Subject: Response to Discontinuation of Safety Evaluation for Source Model Nos. INIS-SF-CS-1J and INIS-SF-CS-2J.

International Isotopes Inc. Response

INIS-SF-CS-1J

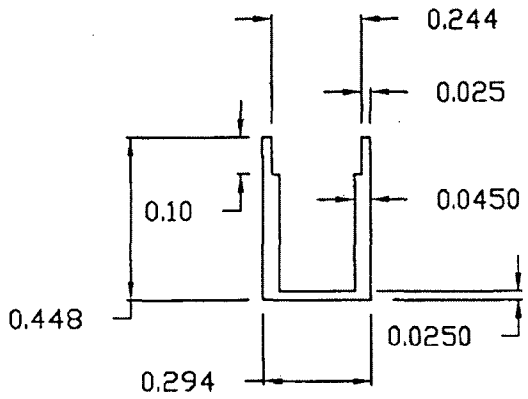
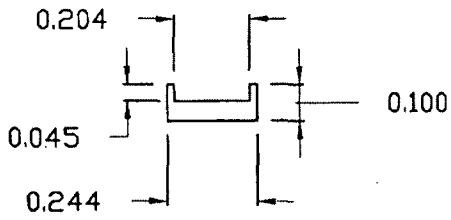
2. *You provided a test report for the source capsules (third encapsulation). However, it is not evident that the testing was conducted on fully assembled source capsules containing doubly encapsulated sources with Cs-137, that have reached the end of their useful life. Please provide procedures for, and results of, prototype testing for such fully assembled source capsules. Please also indicate how the tested source capsules were evaluated to determine containment of the radioactive material, such as leak testing.*

The internal void volume (free volume) between the third encapsulation and the inner slugs were verified to be greater than 0.1 cm^3 which supported non-radioactive leak testing of the prototype sources in accordance with Annex A of ANSI/HPS N43.6-1997, refer to the dimension tables provided below.

INIS-SF-CS-1J	
Third Encapsulation	
Inner Length:	0.820 cm
Inside Diameter:	0.518 cm
Inner Volume:	0.173 cm^3
Encapsulated Slug	
Outer Length:	0.300 cm
Outside Diameter:	0.300 cm
Outside Volume:	0.021 cm^3
Free Volume:	0.157 cm^3
